Service Bulletin

Bulletin No.: 23-NA-051

Subject: Information on New Cell Chemistry N2.2A Vehicle/Pack Identification

6300609

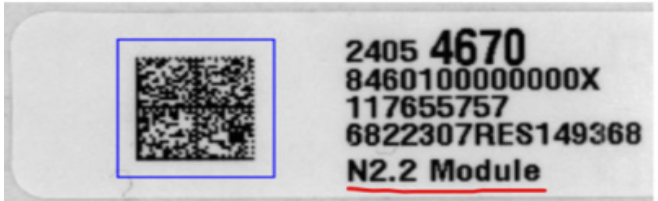
Involved Region or Country	North America Only
Additional Options (RPOs)	Equipped with RPO EKZ
Condition	Due to manufacturing changes in cell chemistry, certain 2023 Bolt EV and EUV vehicles will be built with N2.2A chemistry cells in the High Voltage Battery pack. N2.2A cells cannot be used in a vehicle designed for N2.2 cells, and N2.2 cells cannot be used in a vehicle designed for N2.2A cells. Additionally, cell chemistries cannot be mixed within a pack. An N2.2A CMA (section) cannot be put into an N2.2 pack, and vice versa.
Cause	Dealers must ensure the correct part number is ordered and installed in any vehicle receiving a replacement battery pack or battery section.
Correction	The Investigate Vehicle History (IVH) RPO list for each VIN will identify any vehicle that is built with N2.2A chemistry by having EKZ listed in the Vehicle Build section. EKZ was introduced as a mid-year change for the 2023 model year. All Bolt HV batteries have a label on their exterior designating either N2.2 or N2.2A chemistry. It is important to verify the correct chemistry is being installed into the vehicle both by part number and by looking at the label on the battery itself. When performing internal pack repair of individual sections or components, care must be taken to ensure N2.2 packs are only repaired with N2.2 sections, and N2.2A packs are only repaired with N2.2A sections. Two different cell chemistries can never be put in the same pack. Individual sections will have a label designating N2.2 or N2.2A.

For N2.2A – Mid 2023 Model Year

Inspect HV Battery label (similar label shown above) for N2.2A chemistry and verify vehicle has EKZ.
